BIO-key Hong Kong Limited

Request for Class II Permissive Change

FCC ID: 2AIKJ-BL

Date: Oct. 26, 2017

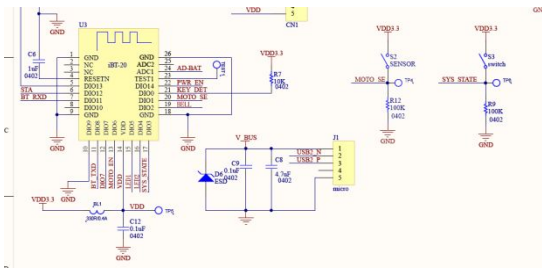
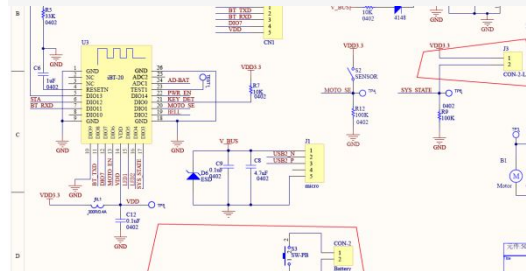
Original device (model BL0509)	New device (model BL1209)
<p>Compared with the new device, NO RF circuit change and there are no such parts marked within red lines like the new device, since S3(a switch) is just on the main PCB board.</p> <p>The function of S3 are the same for both original device and new device</p> 	<p>Compared with Original device, NO RF circuit change and these parts marked within red lines is for S3(a switch) to connect to main PCB board.</p> <p>The function of S3 are the same for both original device and new device</p> 
<p>Other differences between the two device are:</p> <ol style="list-style-type: none"> 1. Color. 2. the size of shape. 3. the size of motor. 4. the capacity of battery. 5. some peripheral circuit components layout(such as model BL0509's S3 is on the <div style="display: flex; align-items: center;">  <div style="margin-left: 10px;"> <p>main board</p>  <p>), but model BL0509's S3 apart the main board and connect to the main board with wires</p> </div> </div>

6. some peripheral circuit components parameters(such as the capacity of C1

1uF is for BL1209,

0.1uF is for BL0509)
